PROPOSED REPLACEMENT

SEPTIC SYSTEM PLAN

LOCUS: 257 WASHINGTON ROAD
RYE, NH
TAX MAP 16 LOT 157

DATE: JUNE 29, 2015
REVISED JULY 10, 2015

PLAN : 1"=20'

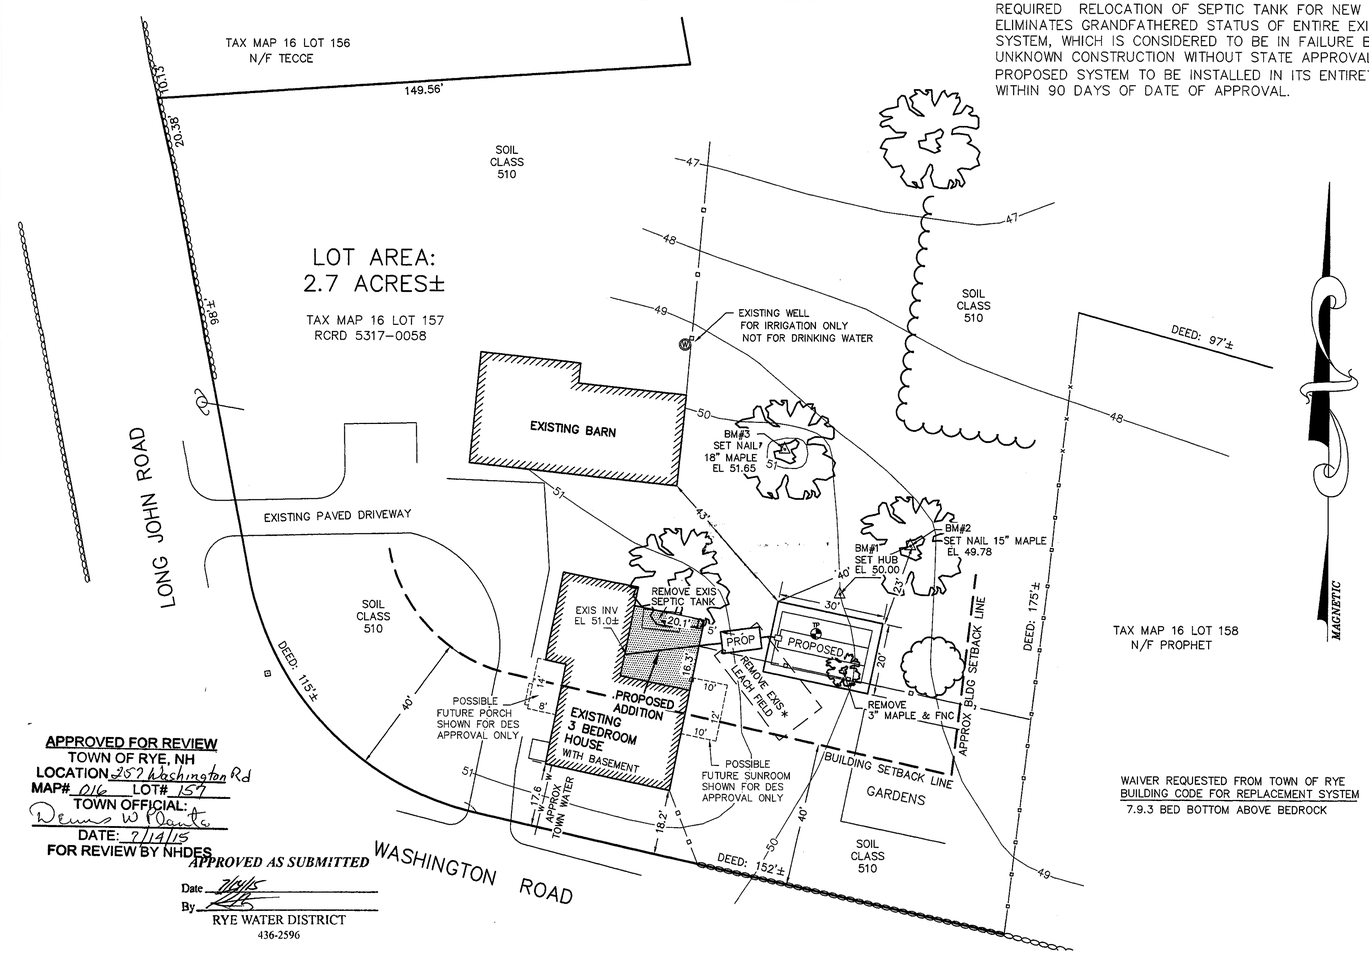
REVISION NOTE PER SUBSURFACE REVIEW:

REQUIRED RELOCATION OF SEPTIC TANK FOR NEW ADDITION ELIMINATES GRANDFATHERED STATUS OF ENTIRE EXISTING SYSTEM, WHICH IS CONSIDERED TO BE IN FAILURE BASED ON UNKNOWN CONSTRUCTION WITHOUT STATE APPROVAL. PROPOSED SYSTEM TO BE INSTALLED IN ITS ENTIRETY WITHIN 90 DAYS OF DATE OF APPROVAL.

PLAN : 1"=20'

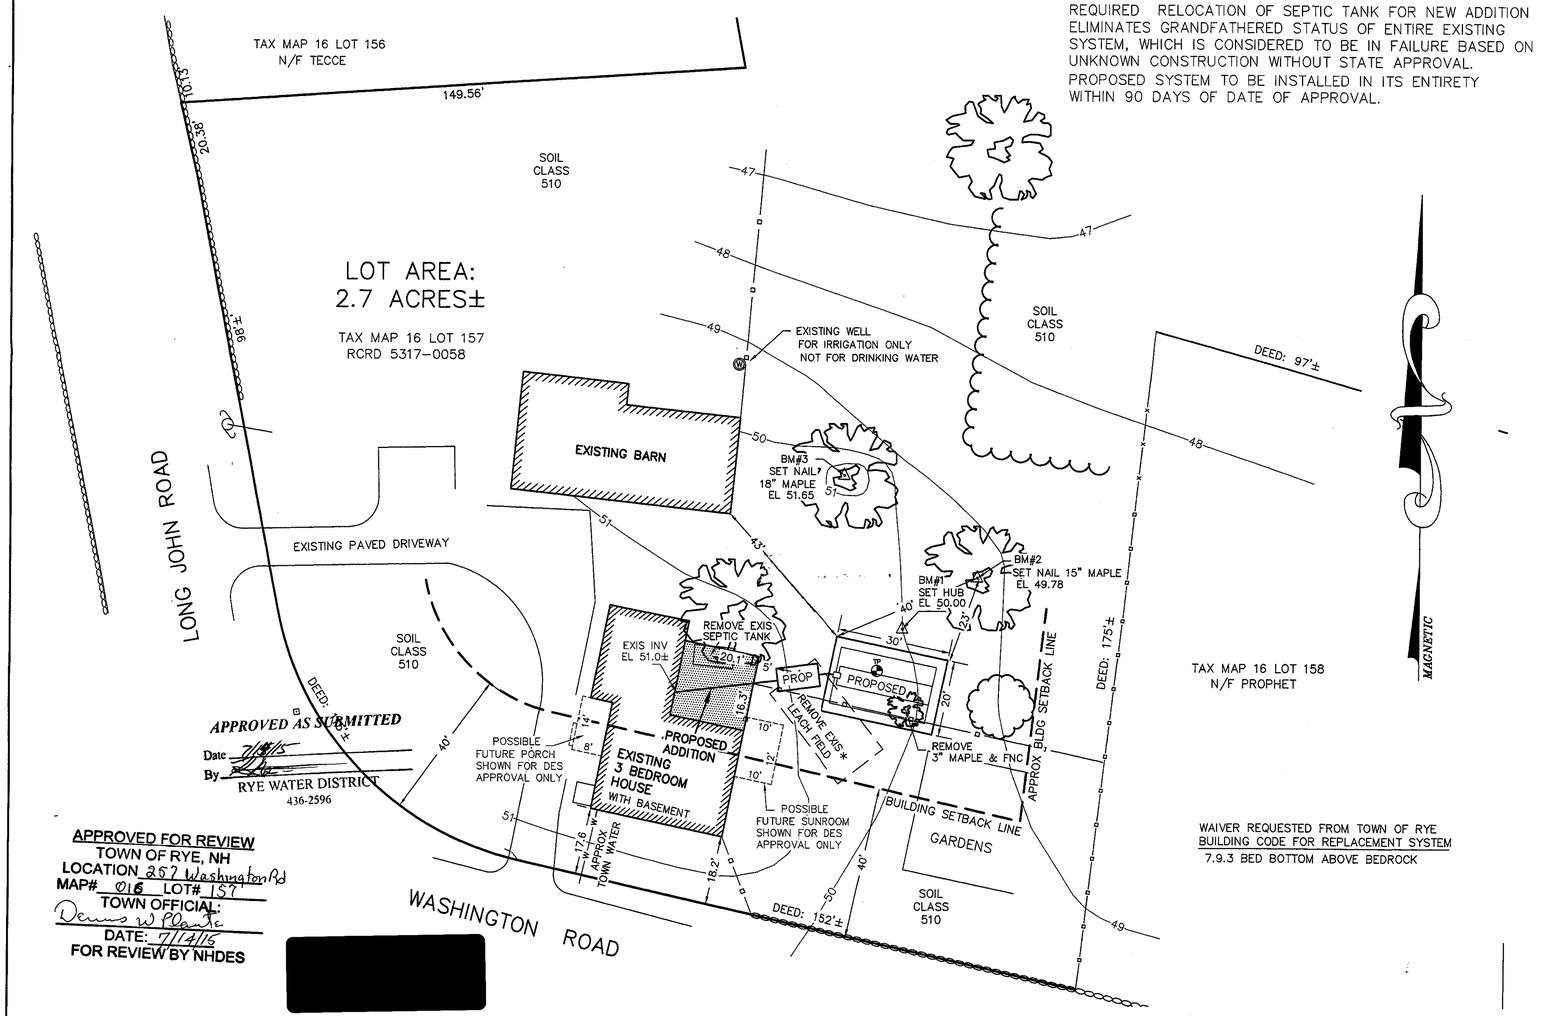
REVISION NOTE PER SUBSURFACE REVIEW:

REQUIRED RELOCATION OF SEPTIC TANK FOR NEW ADDITION ELIMINATES GRANDFATHERED STATUS OF ENTIRE EXISTING SYSTEM, WHICH IS CONSIDERED TO BE IN FAILURE BASED ON UNKNOWN CONSTRUCTION WITHOUT STATE APPROVAL. PROPOSED SYSTEM TO BE INSTALLED IN ITS ENTIRETY WITHIN 90 DAYS OF DATE OF APPROVAL.
